## 2.4 Core Cooling Systems

The information in this section of the reference ABWR DCD, including all subsections, tables, and figures, is incorporated by reference with the following departures.

Figure 2.4.1a Residual Heat Removal System (RHR-A)

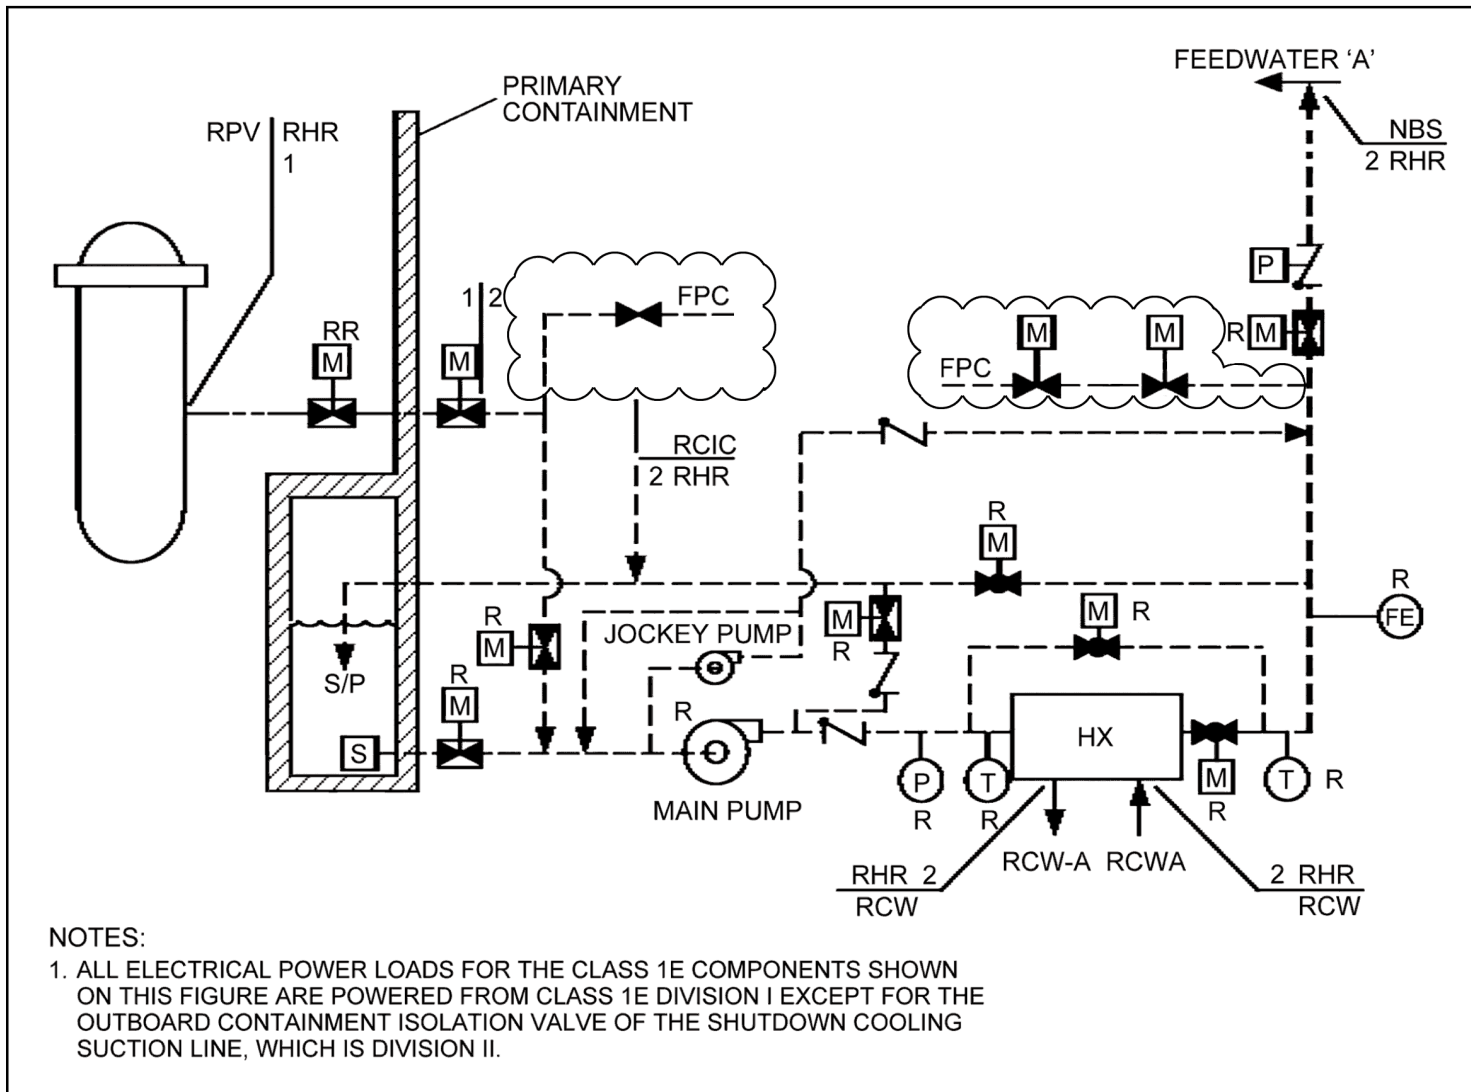
STD DEP T1 2.4-1 (Figure 2.4.1a, Table 2.4.1)

STD DEP T1 2.4-1

~~the shutdown cooling suction line, titled "From FPC."~~ For RHR A and B, the upgraded branch lines from the main pump suction include the path to and including the suppression pool suction valve, the path to the shutdown cooling outboard containment isolation valve, the path to the jockey pump's discharge valve including the jockey pump's bypass line and the path to the (and including the valve) the Fuel Pool Cooling System that branches off the shutdown cooling suction, titled, "From FPC." For RHR-C, the upgraded branch lines include all the paths listed for RHR-A and B plus the pipeline and valves that are part of the AC independent water addition mode that extends from the noncode boundary indicated by "NNS" to the "external connection" outside the "reactor building" and to the Fire Protection System interface indicated by "FP."

Figure 2.4.1b Residual Heat Removal System (RHR-B)

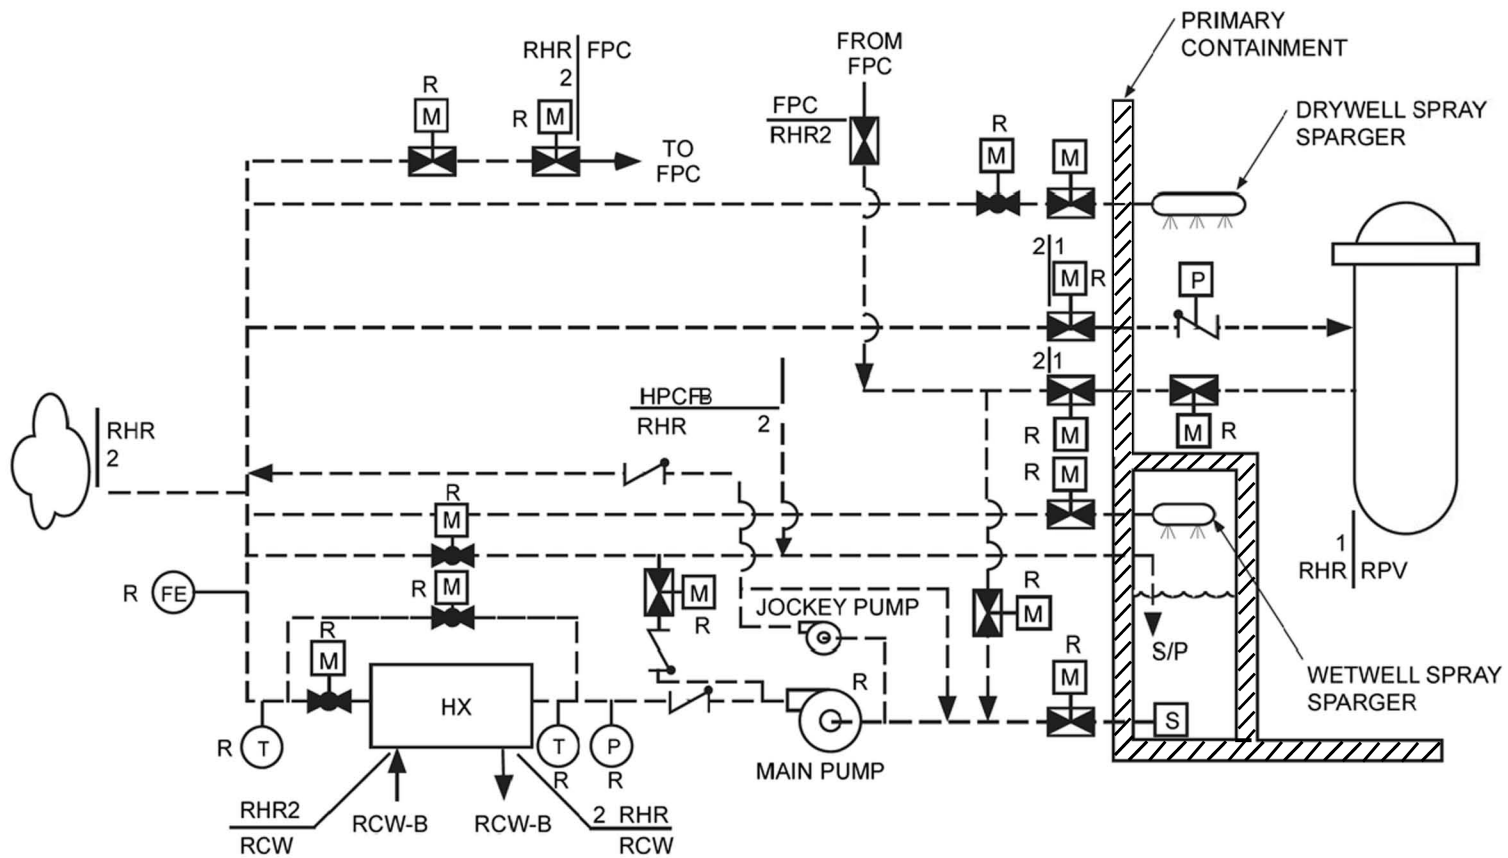
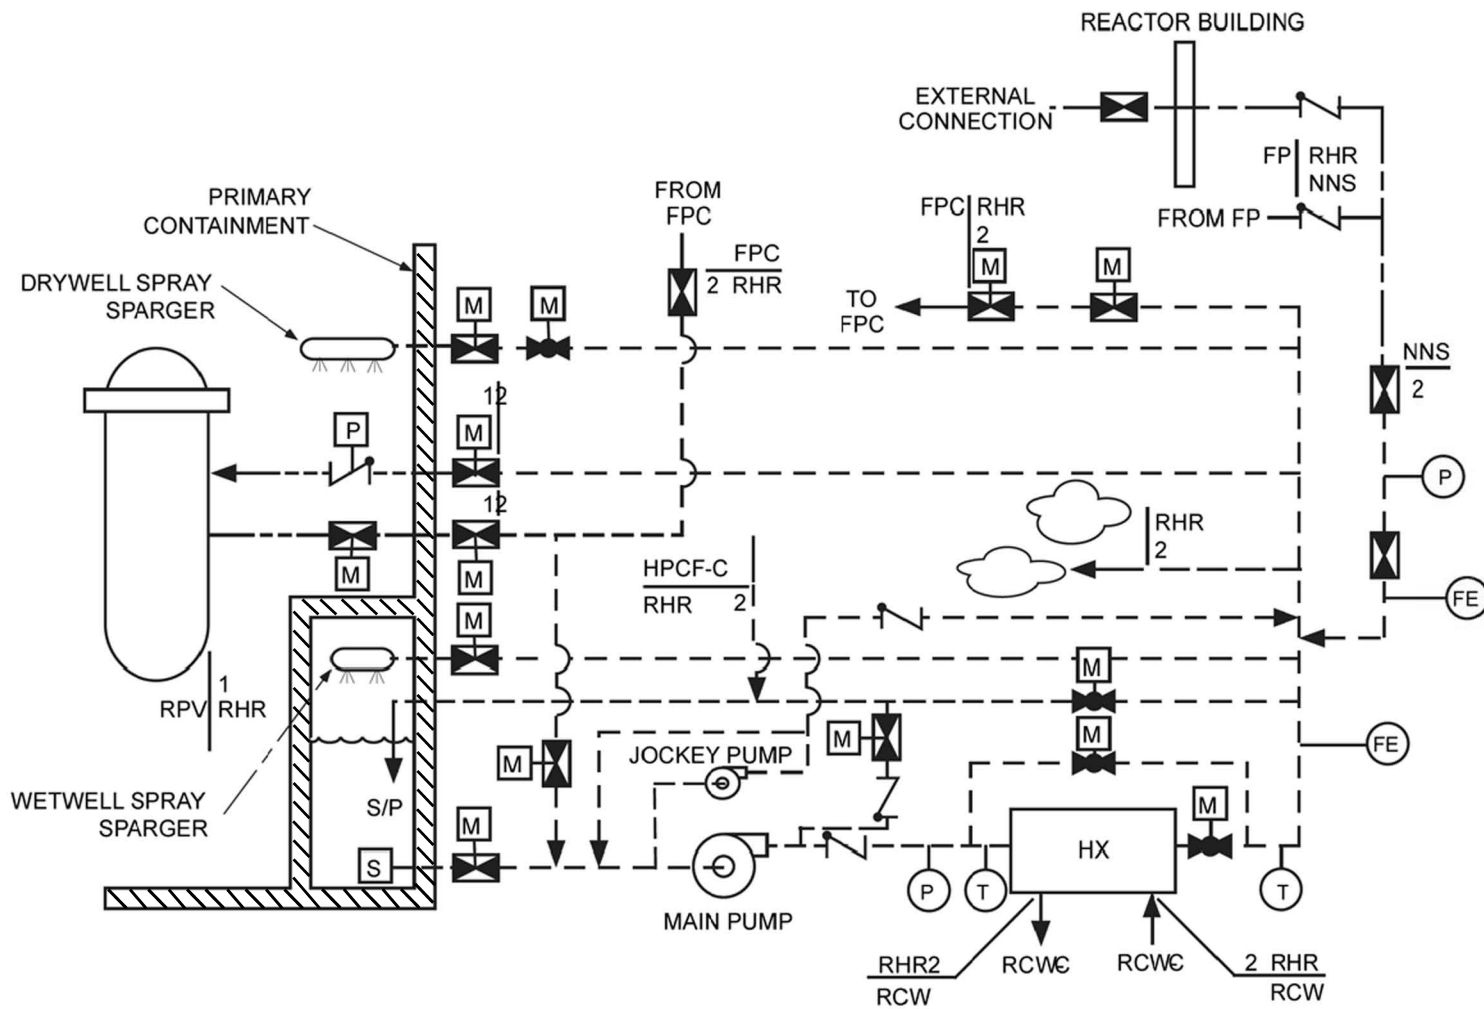
STD DEP T1 2.14-1 (Figure 2.4.1b, Figure 2.4.1c, Figure 2.4.3)

1. ALL ELECTRICAL POWER LOADS FOR THE CLASS 1E COMPONENTS SHOWN ON THIS FIGURE ARE POWERED FROM CLASS 1E DIVISION III EXCEPT FOR THE OUTBOARD CONTAINMENT ISOLATION VALVE OF THE SHUTDOWN COOLING SUCTION LINE, WHICH IS DIVISION I.
2. DRYWELL AND WETWELL SPRAY SPRAGERS ARE COMMON TO DIVISIONS B AND C.

Figure 2.4.2 Leak Detection and Isolation System Interface Diagram

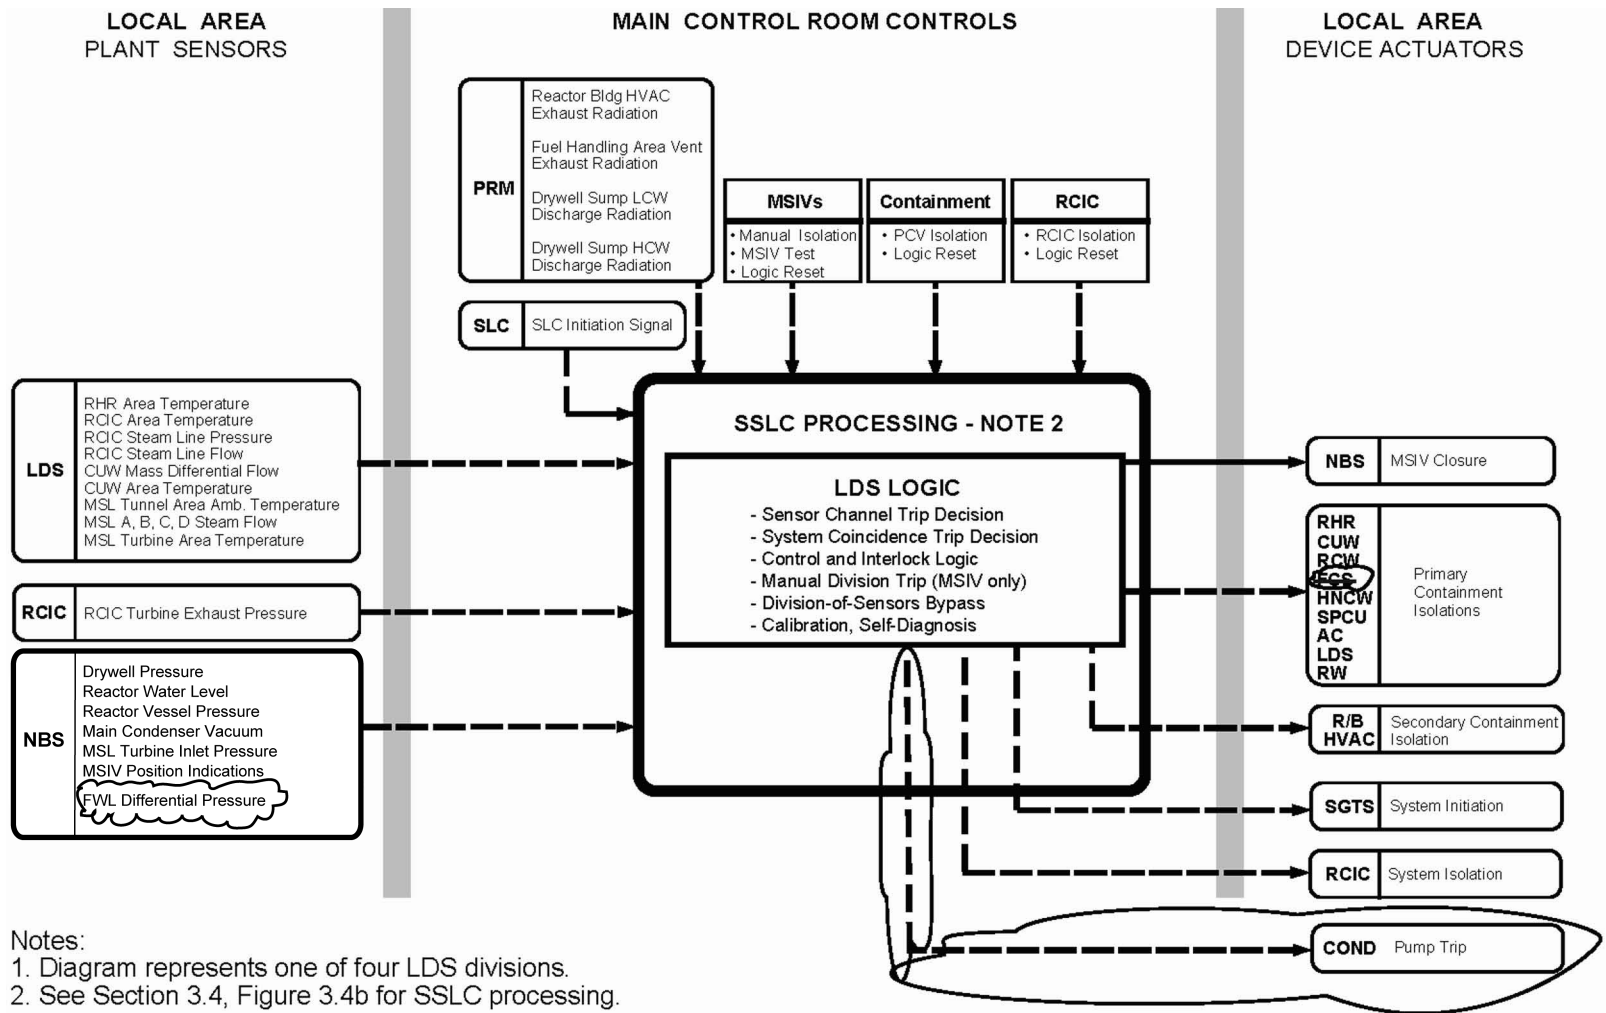
STD DEP T1 2.4-2 (Leak Detection System) Figure 2.4.3

STD DEP T1 2.14-1 (FCS, Figure 2.4.3)

- (9) *Isolation of the Suppression Pool Cleanup (SPCU) System on a signal indicating high drywell pressure or low reactor water level.*
- ~~(10) *Isolation of the Flammability Control System (FCS) on a signal indicating high drywell pressure or low reactor water level.*~~

**Figure 2.4.4a Reactor Core Isolation Cooling System**

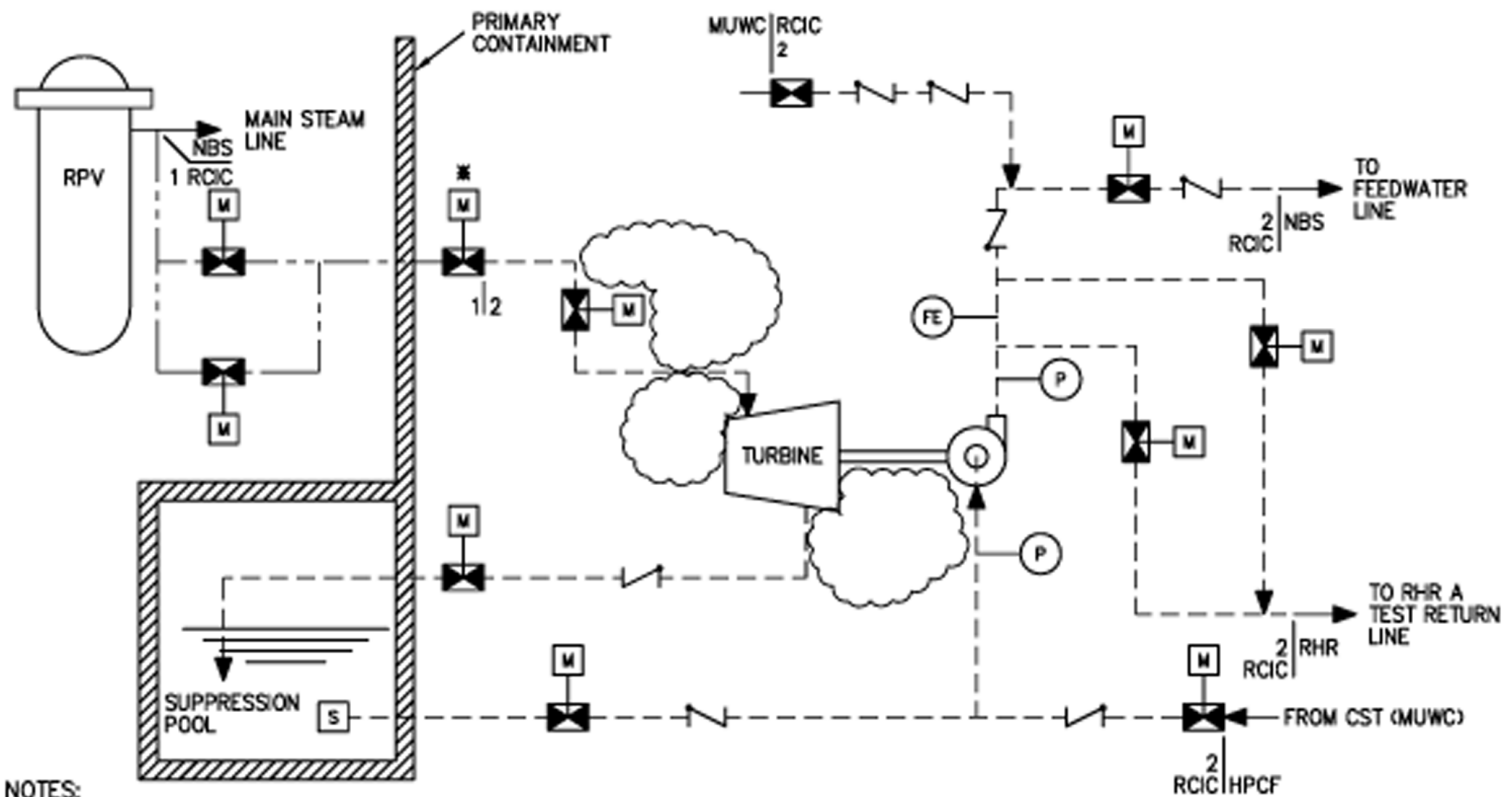
STD DEP T1 2.4-3 (Figure 2.4.4a, Table 2.4.4.)

STD DEP T1 2.4-3

- (1) Piping and component from the pump suction MOV's up to the pump inlet,*
- ~~(2) Barometric condenser and associated equipment.~~*

- NOTES:**
1. RCIC TURBINE IS ~~NOT COVERED BY ASME CODE SECTION II BUT IS DESIGNED, FABRICATED, AND INSTALLED TO SAFETY RELATED STANDARDS AND IS CONSISTENT WITH THE ASME CODE SECTION II REQUIREMENTS. THE TURBINE INCLUDES THE TURBINE TRIP AND THROTTLE VALVE.~~
  2. ALL RCIC SYSTEM COMPONENTS SHOWN ON THIS FIGURE ARE POWERED FROM CLASS 1E DIVISION I EXCEPT FOR THE OUTBOARD CONTAINMENT ISOLATION VALVE (■) WHICH IS CLASS 1E DIVISION II.
  3. ALL RCIC SYSTEM COMPONENTS SHOWN ON THIS FIGURE EXCEPT THE INBOARD CONTAINMENT ISOLATION VALVES, ARE POWERED FROM DC SOURCES.
